Docket Item # 7
BAR CASE# 2008-0028

BAR Meeting
July 30, 2008

ISSUE: Addition/Alterations
APPLICANT: Neil and Sheila Jurinski
LOCATION: 334 Commerce Street
ZONE: CD/Residential

Figure 3: Proposed rear addition elevations

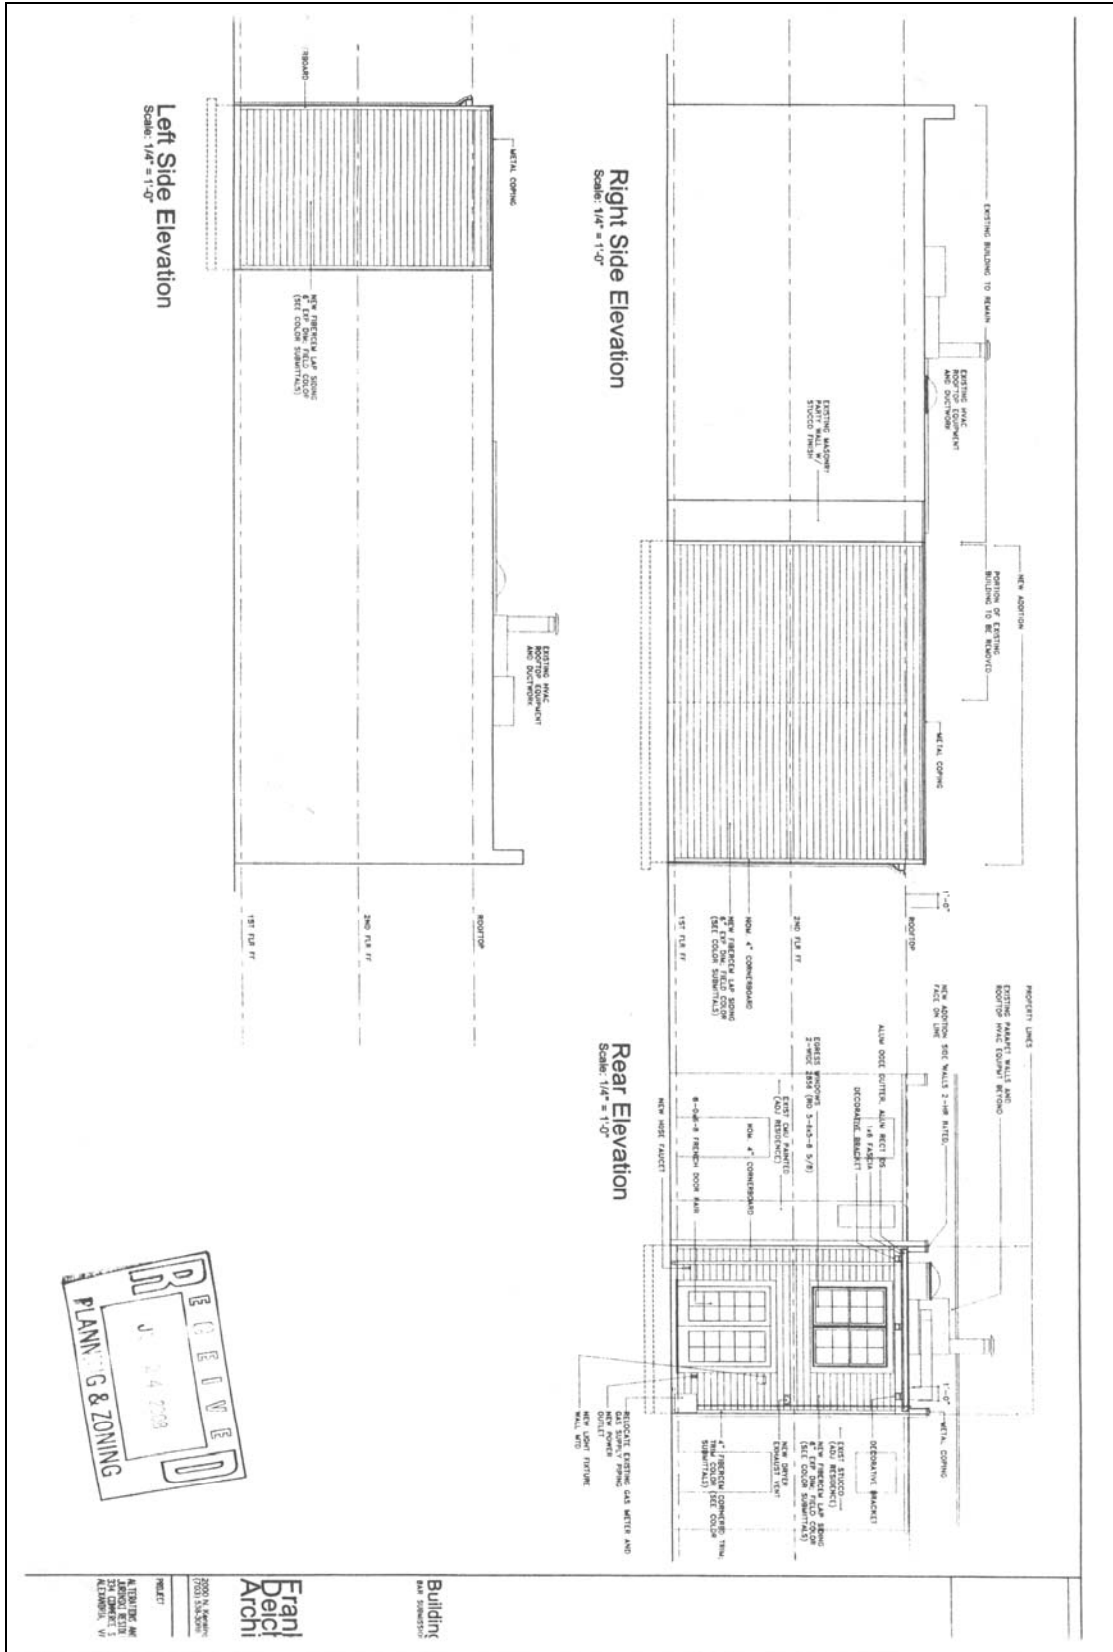
The addition mimics a simple form, with a set of paired French-style doors on the first floor and a paired four-over-four windows on the second floor. The applicant has indicated the windows and doors will be wood, double-glazed, simulated divided light, with spacer bar, but a manufacturer was not identified. A HardiPlank/cementitious siding will be used to clad the addition. The applicant provides color samples for the siding, which are a light green with white trim. Other features of the addition include a new light fixture beside the doors, aluminum gutters, and decorative brackets.

1. That the applicant provide window manufacturer information for Staff review and approval prior to filing for a building permit;
2. That the HardiPlank(fiber cement) siding be smooth finish, and the nails now show in the installation;
